Project	<b>IEEE 802.16 Broadband Wireless Access Working Group</b> < <a href="http://ieee802.org/16">http://ieee802.org/16</a> >	
Title	<b>MS Context Transfer for optimized HO process</b>	
Date Submitted	<b>2008-03-15</b>	
Source(s)	Masato Okuda, Wei-Peng Chen and Yanling Lu  Fujitsu	Voice: Fax: okuda@jp.fujitsu.com
Re:	IEEE 802.16-08/007: "IEEE 802.16 Working Group Letter Ballot Recirc #28b: Announcement"	
Abstract	This contribution proposes MS context transfer method for optimized HO process.	
Purpose	Text proposal for 802.16j Draft Document.	
Notice	<i>This document does not represent the agreed views of the IEEE 802.16 Working Group or any of its subgroups. It represents only the views of the participants listed in the "Source(s)" field above. It is offered as a basis for discussion. It is not binding on the contributor(s), who reserve(s) the right to add, amend or withdraw material contained herein.</i>

# MS Context Transfer for optimized HO process

Masato Okuda, Wei-Peng Chen and Yanling Lu  
Fujitsu

Figure xxx-1 Serving station initiate transfer (Intra-MR)

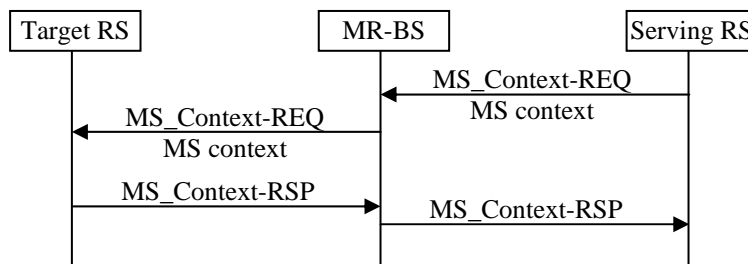
In the Serving station initiated transfer, the serving station may send MS Context-REQ with type=0 (serving station initiated transfer) to the target station, when it receives MOB\_MSHO/BSHO-REQ or MOB\_HO-IND message. Then, the target station sends MS Context-RSP with type=0 (serving station initiated transfer) to the serving station.

The figure xxx-1 and xxx-2 show examples of serving station initiate transfer in Intra-MR and Inter-MR handover, respectively. The MS Context-REQ message sent by the serving station shall contain SS MAC Address TLV and BSID TLV and should contain TLVs related to MS context. The BSID TLV represents the target station. Therefore, when the MR-BS receives the MS Context-REQ from the serving RS, it examines the BSID TLV. If the BSID TLV indicates the MR-BS itself, the MR-BS sends back MS Context-RSP to the serving RS. If it indicates a subordinate RS of the MR-BS, the MR-BS sends MS Context-REQ with type=0 to the subordinate RS. Then the subordinate RS sends back MS Context-RSP to the serving RS through the MR-BS. If the BSID does not indicate a station within the MR cell, the MR-BS sends a message to the backbone network to inform the target station of MS context. The message sent to the backbone is out of scope of this standard.

Figure yyy-1 Target station initiate transfer (Intra-MR)

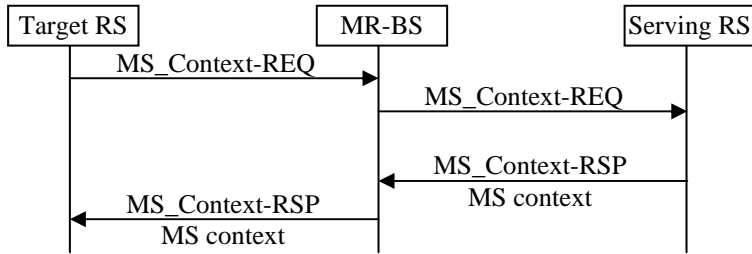
In the Target station initiated transfer, the target station may send MS Context-REQ with type=1 (target station initiated transfer) to the serving station, when it receives a RNG-REQ message containing the Serving BSID TLV from an MS and does not possess context of the MS. Then, the serving station sends MS Context-RSP with type=1 (target station initiated transfer) to the target station.

The figure yyy-1 and yyy-2 show examples of target station initiate transfer in Intra-MR and Inter-MR handover, respectively. The MS Context-REQ message sent by the target station shall contain SS MAC Address TLV and BSID TLV. The BSID TLV represents the serving station. Therefore, when the MR-BS receives the MS Context-REQ from the target RS, it examines the BSID TLV. If the BSID TLV indicates the MR-BS itself, the MR-BS sends back MS Context-RSP to the target RS. If it indicates a subordinate RS of the MR-BS, the MR-BS sends MS Context-REQ with type=1 to the subordinate RS. Then the subordinate RS sends back MS Context-RSP to the target RS through the MR-BS. The MS Context-RSP should contain TLVs related to MS context. If the BSID does not indicate a station within the MR cell, the MR-BS sends a message to the backbone network to inform the target station of MS context. The message sent to the backbone is out of scope of this specification.
